1964 Corvette: Service Bulletin: Neutral Safety Switch Malfunction

Model and Year: 1964 Corvettes with Powerglide Transmissions

Bulletin No: DR #658

Date: March 10, 1964

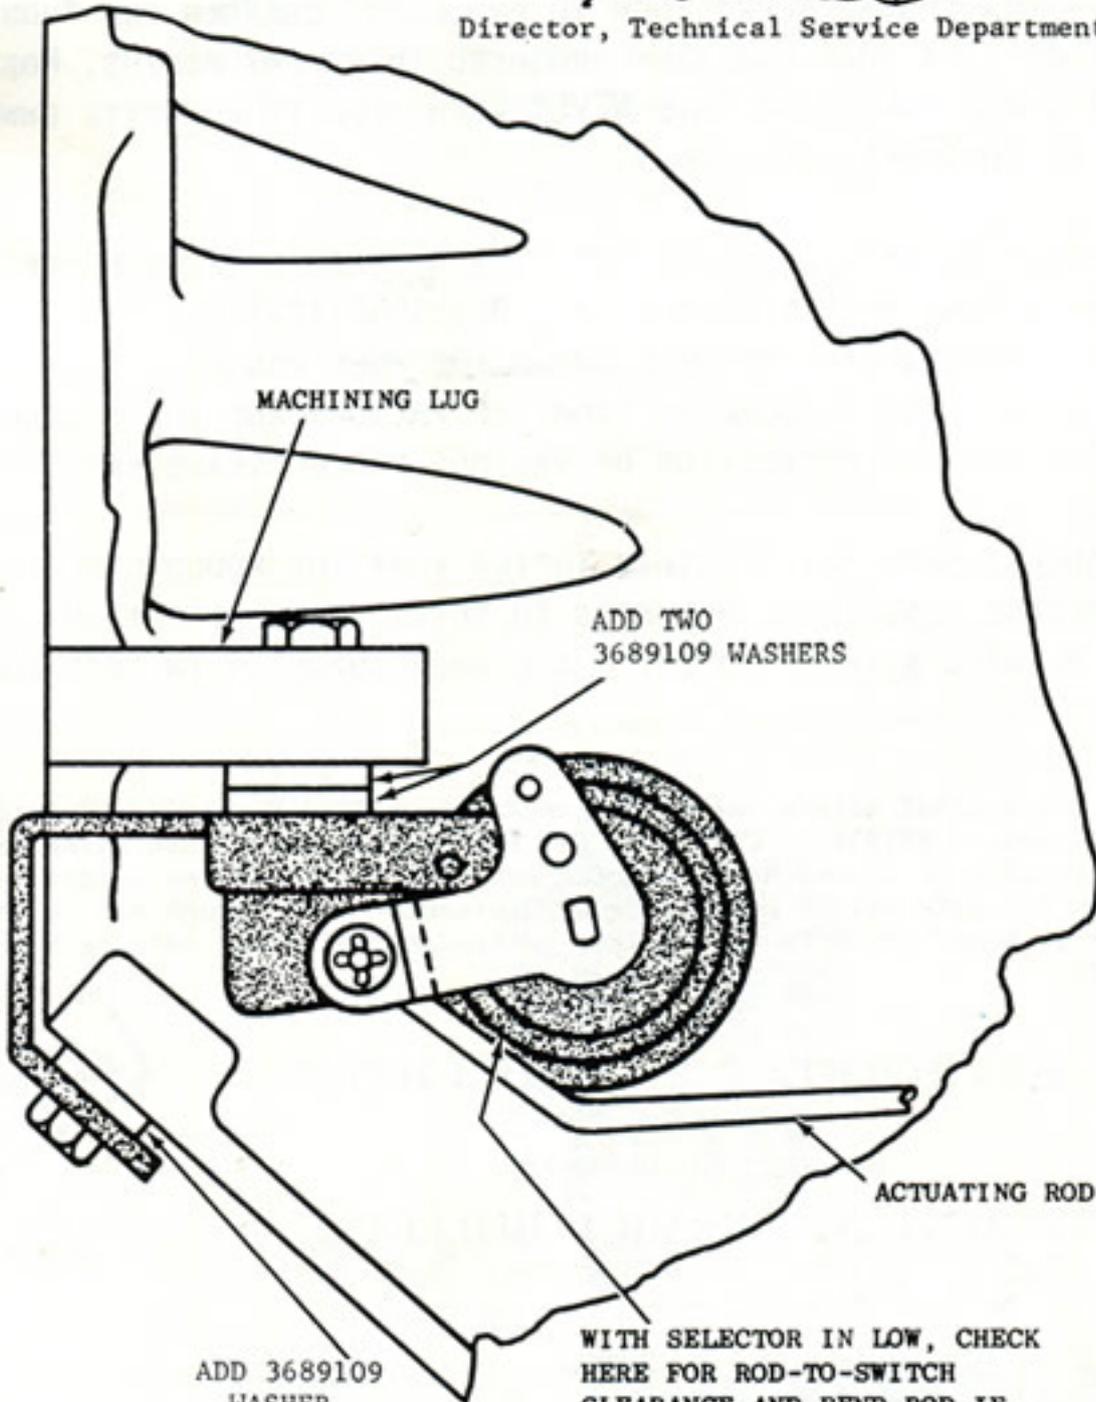
Interference between the neutral safety switch and the underbody may exist on some early production Corvette Models with Powerglide transmissions.

This could result in the engine being started while the transmission selector is in a drive position. In addition, the added load imposed on the shift linkage by the misalignment causes a reduction or loss of detent feel when the transmission is shifted manually. The transmission might then be accidentally operated between ranges and internal damage could result.

Correction of switch malfunction may be made by shimming the switch assembly downward as shown in the attached sketch. Note that operating clearance must exist between the switch body and the switch actuating rod after the shimming operation is completed.

WITH SELECTOR IN LOW, CHECK HERE FOR ROD-TO-SWITCH CLEARANCE AND BEND ROD IF NECESSARY. TEST ACTION OF SWITCH AFTER BENDING ROD & ADJUST LENGTH OF ROD AS REQUIRED BY TURNING THREADED PIVOT.
